SERVICE BULLETIN No. 26 R5	DOA No. EASA.21J.020
--	---------------------------------------	---------------------------------

Subject: a) **De-Ice Wiring on MTV-27-1 Propeller series
With Dual - Element De-Icing Boots (3 wires)**

b) **Length of the spinner fixture screws**

Affected Propeller: **MTV-27-1 Propeller series equipped with dual - element boots (3 wires).**

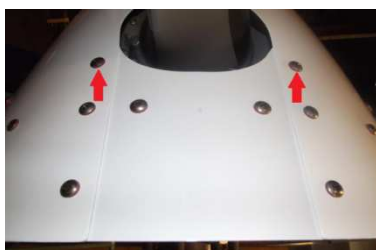
The spinner screws C-306-9 (overall length 16,5 mm / 0,65 inch) should be replaced by the spinner screw type C-306-8 (overall length 15 mm / 0,59 inch) and spinner screw type C-306-7 (overall length 13,40 mm / 0,53 inch)

which fixing the filler plate on spinner dome between front and rear spinner bulkhead. The 10 spinner screws (see red marks on picture beside) C-306-8 should be replaced by the 10 spinner screws C-306-7 that they do not protrude the self locking nut which can wear out the de-ice cable.

Optional: The spinner assembly comes without the spinner screw according the picture below.

Note: In this case all the same spinner screw type C-306-8 can be used.

All the present spinner assemblies which are in service can be used without that spinner screw according the picture below.
